Making the jitter specs for 400GAUI-8 and 400GBASE-DR4 compatible

Piers Dawe and Oded Wertheim

Mellanox

Wander and the 400GBASE-DR4 PMA

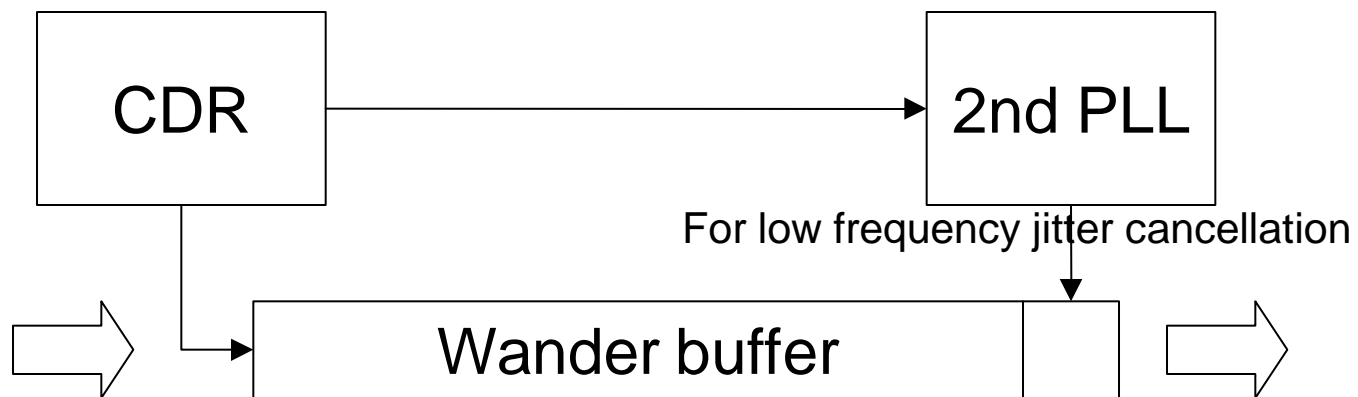
- 100G lane output jitter requirement for a specific frequency is half the peak-to-peak value (as 1 UI at 100G = $\frac{1}{2}$ UI at 50G)
- As a result, a PMA with 50G input lanes and 100G output lanes is required to implement a de-jitterizer function.
- The de-jitterizer function includes:
 - A 2nd PLL to cancel the low frequency jitter
 - Clean clock for 2nd PLL
 - Wander buffer with a size of at least $\frac{1}{2}$ max peak-to-peak jitter

Wander and the 400GBASE-DR4 PMA

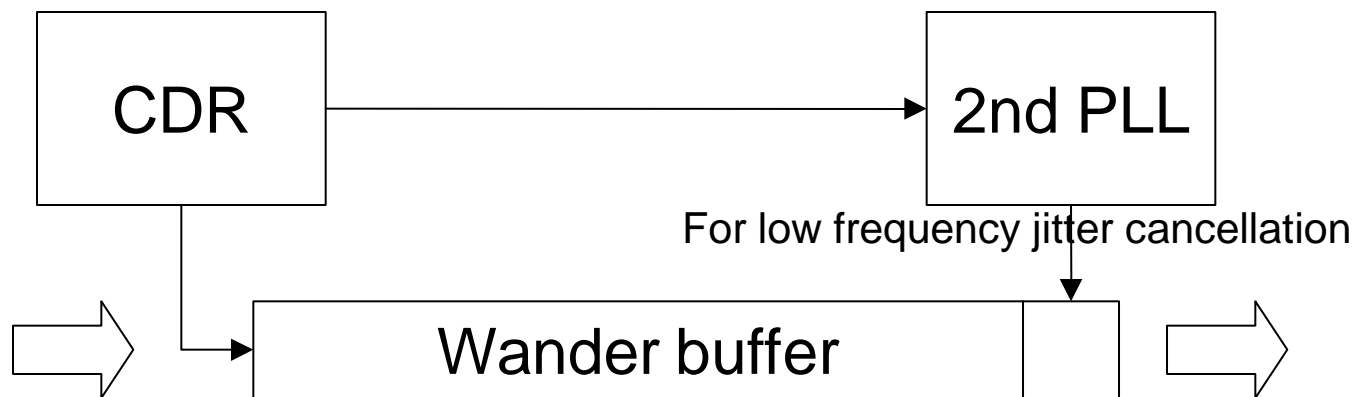
- Adding a de-jitterizer function costs unnecessary power and area
 - While reducing the low frequency wander has no real value to the DR4 receiver
- And worse, the max peak-to-peak jitter appears to be unbounded, so a "very large" buffer would be needed
 - At a minimum, the spec needs to work with a finite buffer

50G/lane jitter tolerance mask

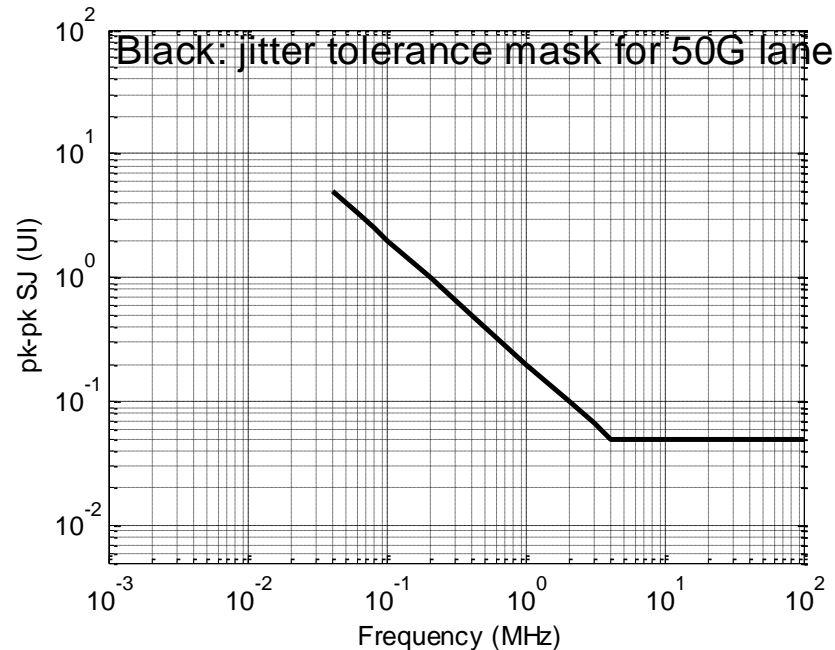
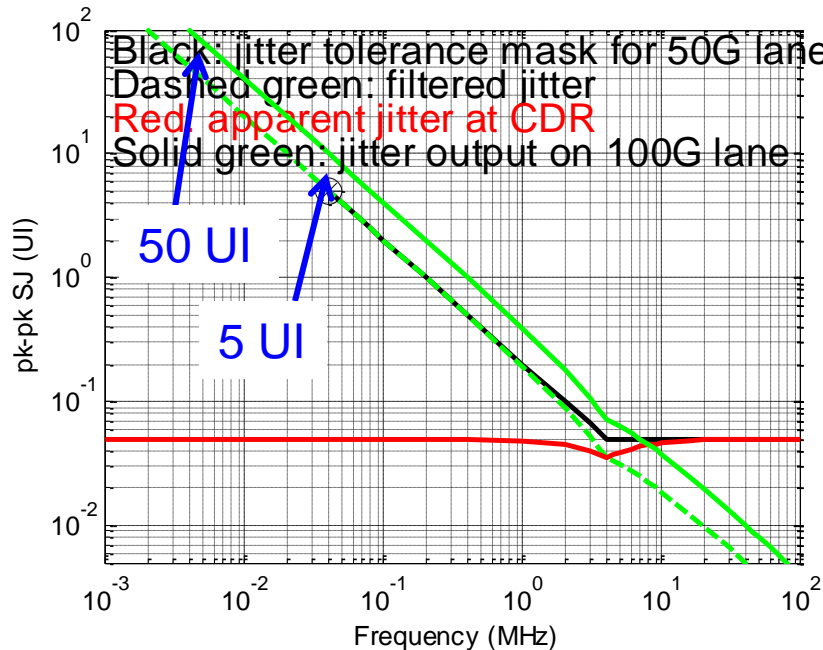
- Module with 400GAUI-8 electrical input, 400GBASE-DR4 optical output
- Or 100GAUI-2 electrical input, 100GBASE-DR optical output
- The module's electrical input can be tested at six SJ points on the mask on the left
- The host's output jitter must be near or below the (extrapolated?) mask
- This is a jitter mask for the 100G optical lanes, but 1 UI is different there

Jitter, apparent jitter and transferred jitter

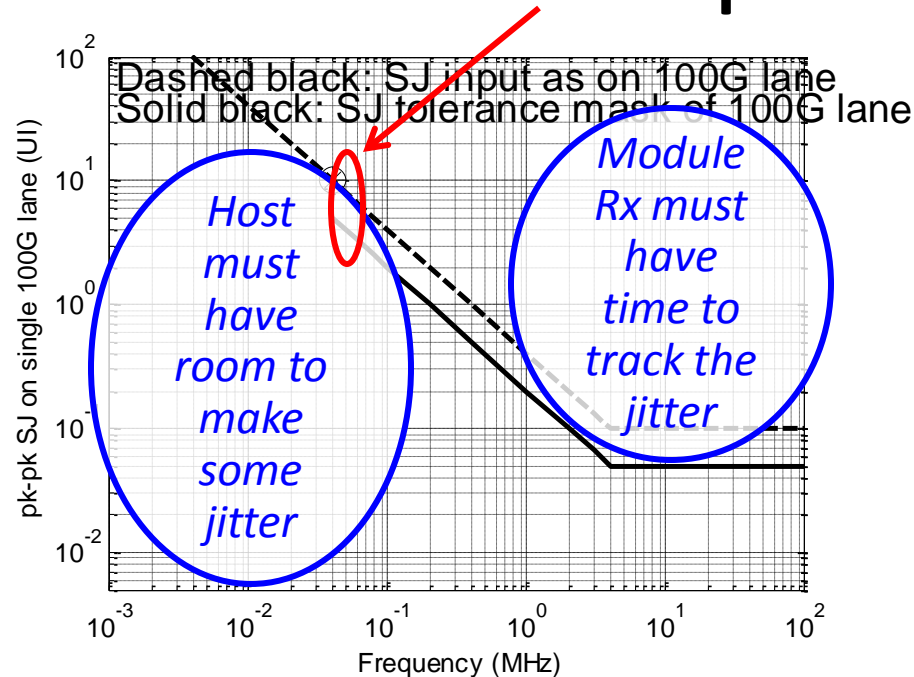
- Module with a conventional CDR (with minimum bandwidth) transfers jitter at low f (dashed green), blocks jitter at high f (electrical signal appears to the module to have the red jitter)
- 1 UI out (100G optical lane) is half as long as 1 UI in (50G electrical lane); the early or late bits from two lanes have to be sent out on one lane

- So the jitter after the input CDR (solid green line) is about twice what is allowed
- Add a buffer (FIFO) and a second PLL as on slide 4. This costs power and requires a low noise second PLL
- How large a FIFO? 5 UI / lane? 50 UI / lane? 500 UI / lane? More?
- The spec doesn't work

The black lines must come together at low frequencies

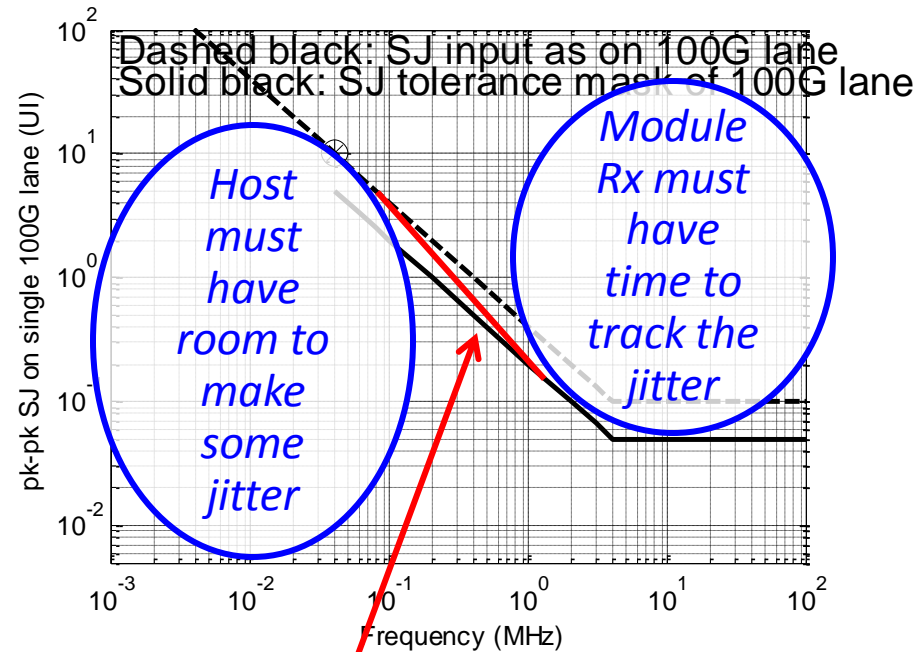
- The two lines are the wrong way round at low frequencies
- Need to make the solid line equal or higher than the dashed line at low frequencies
 - this was hinted in ghiasi_3bs_01a_0116
- There may be more than one way to do this
 - e.g. move the solid black line up

... with a steeper line

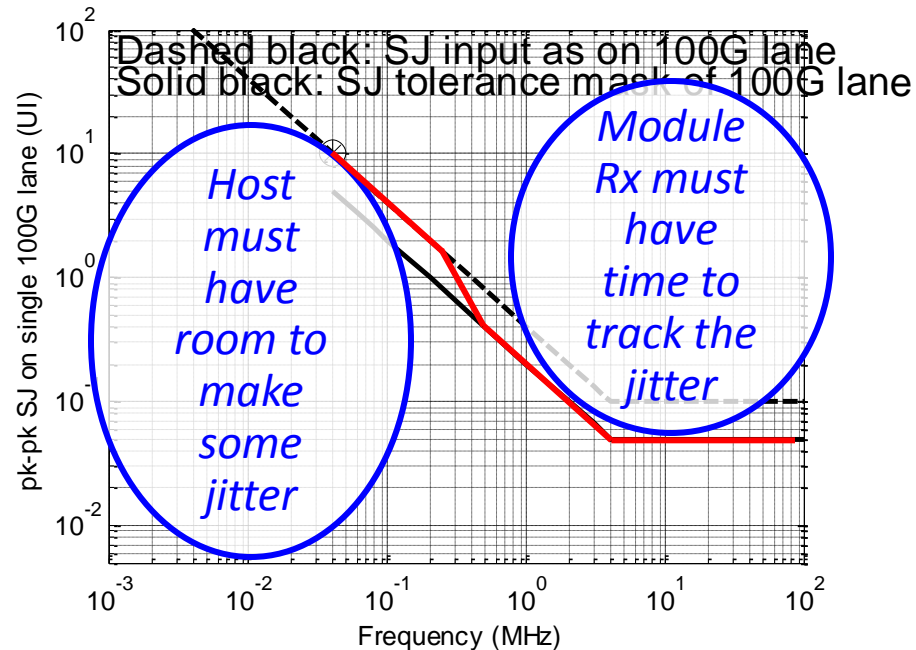
- If the 50G host and the 100G Rx won't move,
- the line between them has to be steeper
 - That's OK, CDRs are typically 2nd order
 - We have used a 1st order reference CRU for simplicity, but now we have a motivation to do something more

- One way would be to modify the 100G jitter tolerance mask and reference CRU as the red line
- A short second order section can be implemented with real resistors and capacitors, or digitally
